Southern Nuclear Operating Company
Vogtle Electric Generating Plant Units 3 and 4
Revised Request for License Amendment and Exemption:
Resolution of Auxiliary Building Wall Thickness and Description Inconsistencies
(LAR-16-033R1)

Revised Request for License Amendment:

Resolution of Auxiliary Building Wall Thickness and Description Inconsistencies

(LAR-16-033R1)

Figure 1: General View of Auxiliary Building Column Line 1 Wall Sections based upon Current COL Appendix C (and plant-specific Tier 1) Table 3.3-1 Dimensions

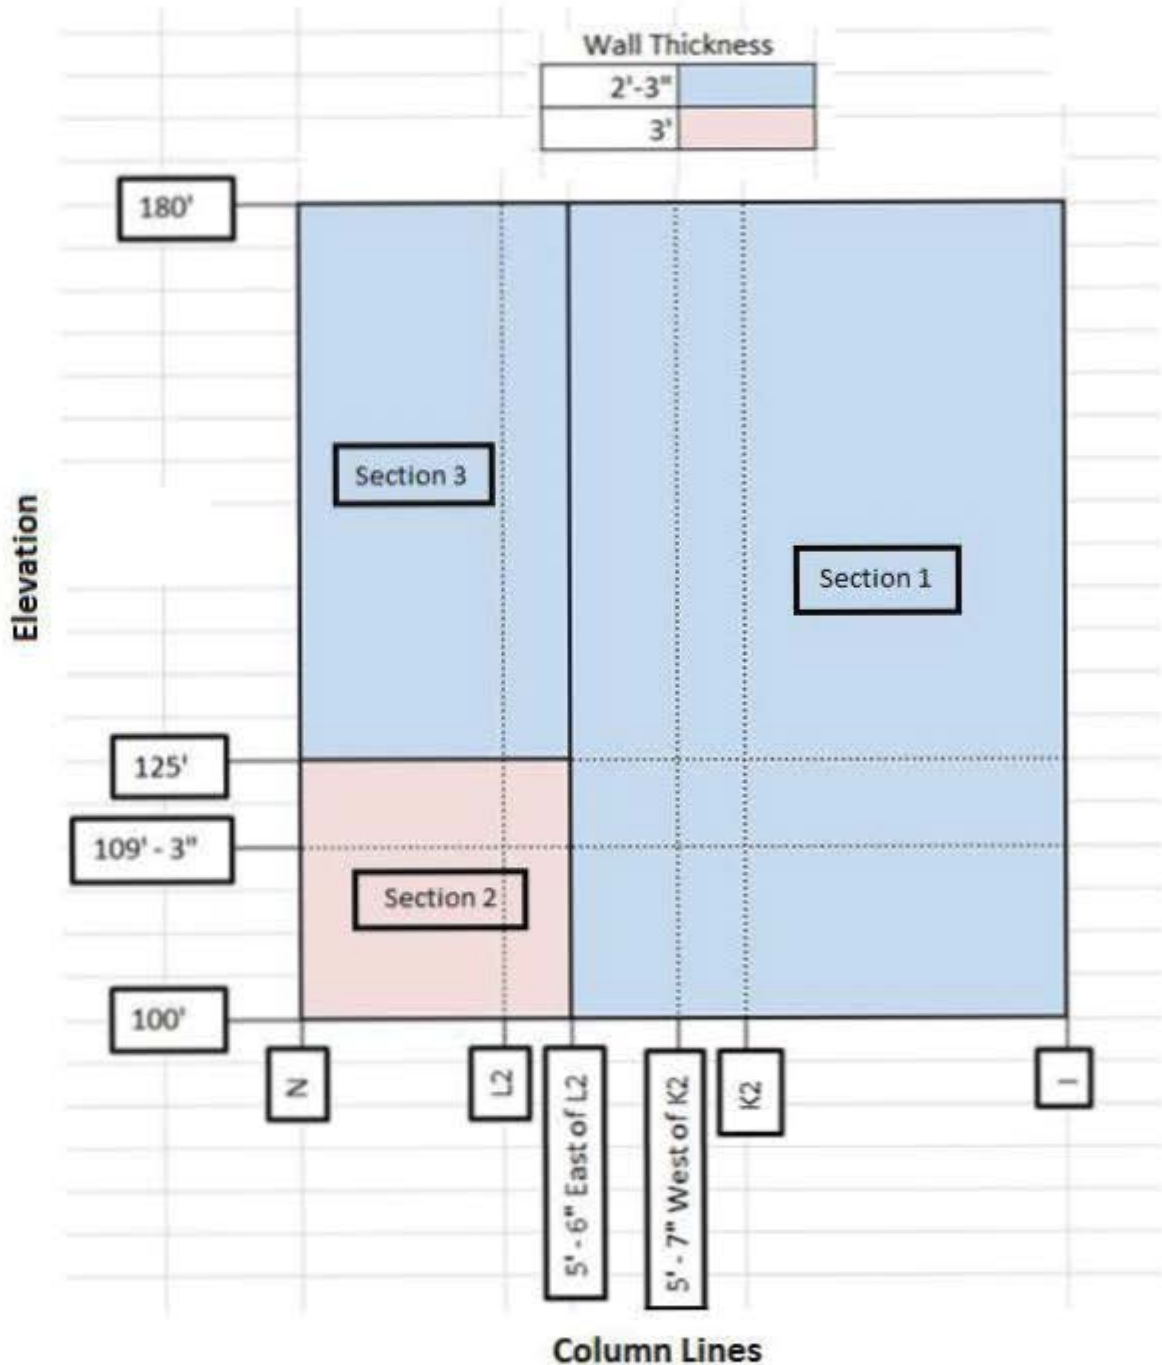
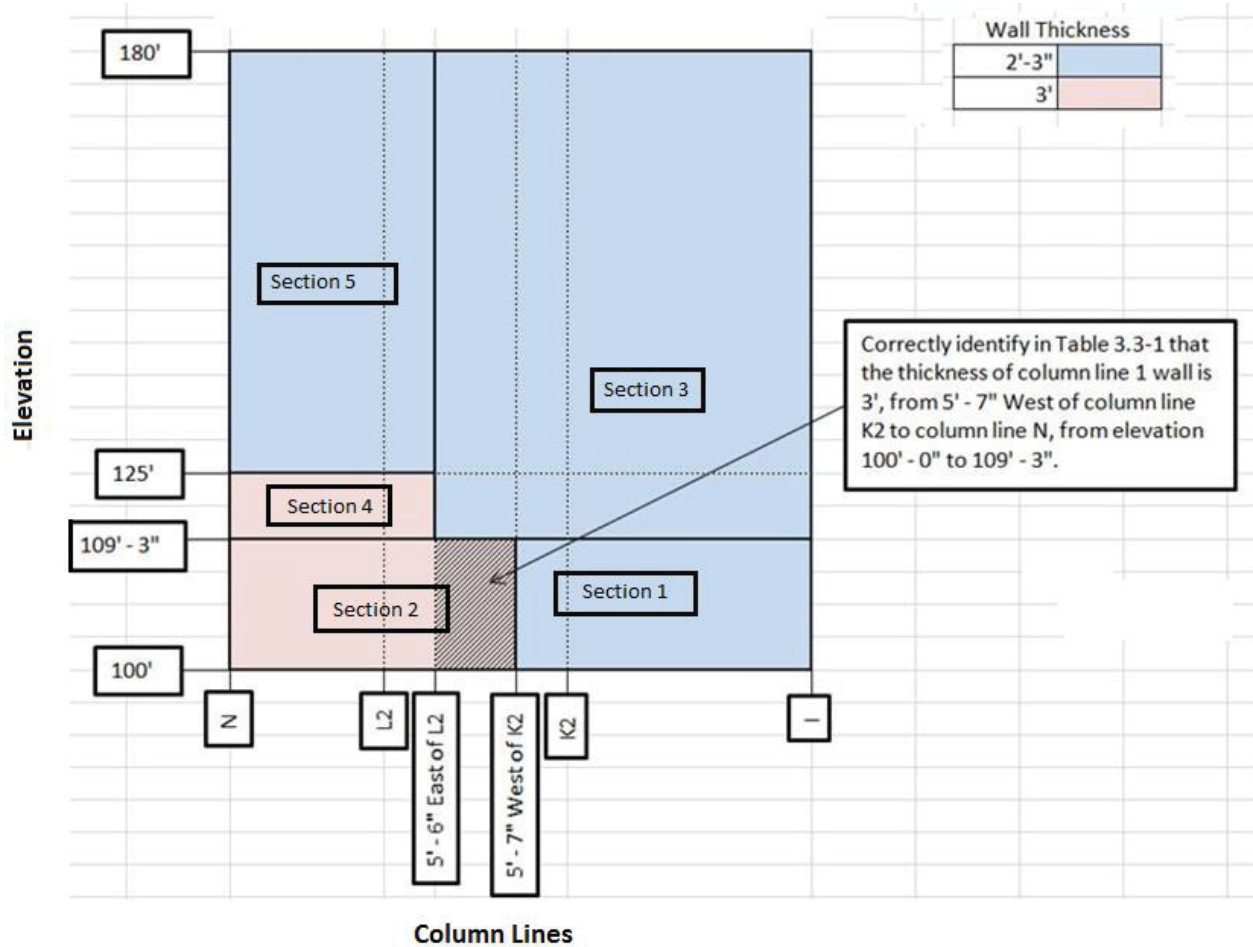
In COL Appendix C (and plant-specific Tier 1) Table 3.3-1, the thicknesses of the auxiliary building column line 1 wall sections above elevation 100'-0" are currently defined as follows:

- 2'-3", from column line I to 5'-6" east of column line L-2, from elevation 100'-0" to 180'-0" (Section 1 of Figure 1 below);
- 3'-0", from 5'-6" east of column line L-2 to column line N, from elevation 100'-0" to 125'-0" (Section 2 of Figure 1 below); and
- 2'-3", from 5'-6" east of column line L-2 to column line N, from elevation 125'-0" to 180'-0" (Section 3 of Figure 1 below).

These wall thicknesses are inconsistent with the wall thicknesses that are inferred or specifically identified in COL Appendix C (and plant-specific Tier 1) Figures 3.3-1, 3.3-6, 3.3-7, 3.3-8, and 3.3-9; and associated UFSAR Figures 1.2-7, 1.2-8, 1.2-9, 1.2-

10, 1.2-11, 1.2-13, 1.2-14 and 3.7.2-12, Sheets 3, 4, 5, 6, and 8; and the AP1000 design documentation, which are as follows:

- 2'-3", from column line I to 5'-7" west of column line K-2, from elevation 100'-0" to 109'-3" (Section 1 of Figure 2 below);
- 3'-0", from 5'-7" west of column line K-2 to column line N, from elevation 100'-0" to 109'-3" (Section 2 of Figure 2 below);
- 2'-3", from column line I to 5'-6" east of column line L-2, from elevation 109'-3" to 180'-0" (Section 3 of Figure 2 below);
- 3'-0", from 5'-6" east of column line L-2 to column line N, from elevation 109'-3" to 125'-0" (Section 4 of Figure 2 below); and
- 2'-3", from 5'-6" east of column line L-2 to column line N, from elevation 125'-0" to 180'-0" (Section 5 of Figure 2 below).

- Table 3.3-1 is revised to identify the listed thicknesses of the auxiliary building column line 1 wall, while identifying the same radiation shielding function as the current column line 1 wall entries, as follows:
 - 2'-3", from column line I to 5'-7" west of column line K-2, from elevation 100'-0" to 109'-3";
 - 3'-0", from 5'-7" west of column line K-2 to column line N, from elevation 100'-0" to 109'-3";
 - 2'-3", from column line I to 5'-6" east of column line L-2, from elevation 109'-3" to 180'-0";

- 3'-0", from 5'-6" east of column line L-2 to column line N, from elevation 109'-3" to 125'-0".
- Table 3.3-1 is revised to identify the listed thickness of the auxiliary building column line I wall as follows:
 - 2'-0", from column line 3 to column line 4, from elevation 100'-0" to the roof.
- Table 3.3-1 is revised to identify the wall location for the labyrinth wall between column lines 3 and 4 and between J-1 and J-2 from elevation 82'-6" to 92'-6" as being 5'-2" from J-2.

- Subsection 3H.5.1.1 is revised to identify that the thicknesses of the auxiliary building column line 1 wall above grade (elevation 100'-0") are as follows:
 - 2'-3", from column line I to 5'-7" west of column line K-2, from elevation 100'-0" to 109'-3";
 - 3'-0", from 5'-7" west of column line K-2 to column line N, from elevation 100'-0" to 109'-3";
 - 2'-3", from column line I to 5'-6" east of column line L-2, from elevation 109'-3" to 180'-0";
 - 3'-0", from 5'-6" east of column line L-2 to column line N, from elevation 109'-3" to 125'-0";
 - 2'-3", from 5'-6" east of column line L-2 to column line N, from elevation 125'-0" to 180'-0".
